**HISTORIC PRESERVATION ADVISORY COMMISSION
MEMORANDUM**

Meeting Date: August 10, 2022

RE: Planning Application 2022-00000054/HDR (Heslin Construction); 10115 West River Street (APN 019-090-031); Owners/Applicants: Kim & Matt Heslin

Figure 3: Proposed front door.

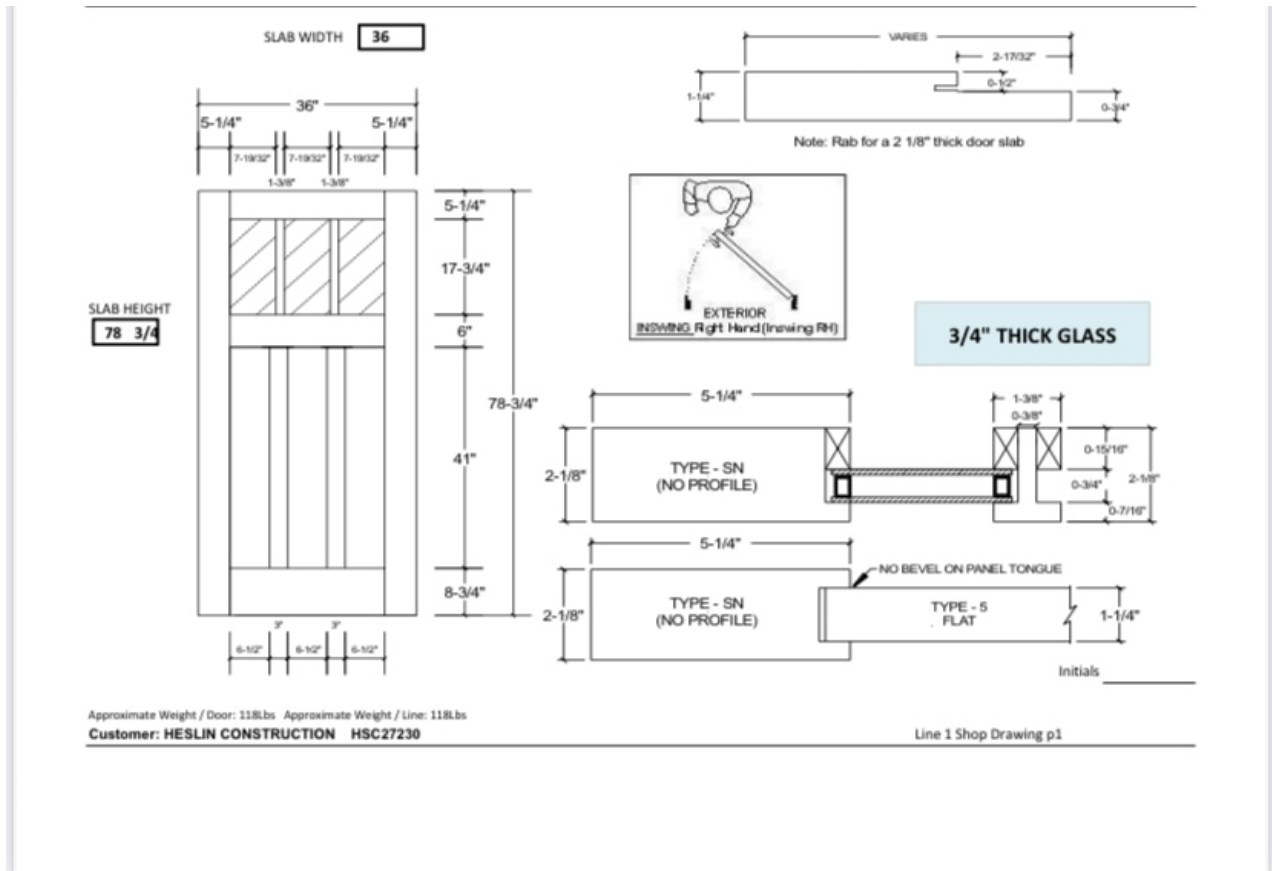
The applicant proposes replacing the door of the main entrance (see Figures 3 and 4). The door replacement is proposed to be sized and hung in-kind with the existing door. The door is manufactured by High Sierra Custom Doors and composed of vertical grain Douglas fir with clear glass panels.

The Historic Design Guidelines identify that doors are some of the most important character-defining features of a historic structure. They give scale to a building and provide visual interest to the composition of individual facades. Additionally, the Guidelines state that when it is necessary to replace a door, the replacement should match the original design as closely as possible. Staff is unclear about the composition of the original door; however, the Truckee Historic Resource Inventory identifies the replacement of the modern door as a restoration opportunity. This includes using the same material (wood) as used historically, matching the number and size of panels, maintaining the position and proportion of historic openings, and if glass is to be used in a door it should be clear, any kind of tinting is inappropriate (*Design Guidelines for Individual Building Components 5.G*).

- 1) Are the proposed exterior modifications appropriate for a Category B ("Contributory") building in the River Character Area, and consistent with the overall intent of the Downtown Specific Plan Historic Design Guidelines?
- 2) Does the HPAC support use of the proposed materials for the front door?
- 3) Would the proposed door replacement degrade the integrity of this historic resource?
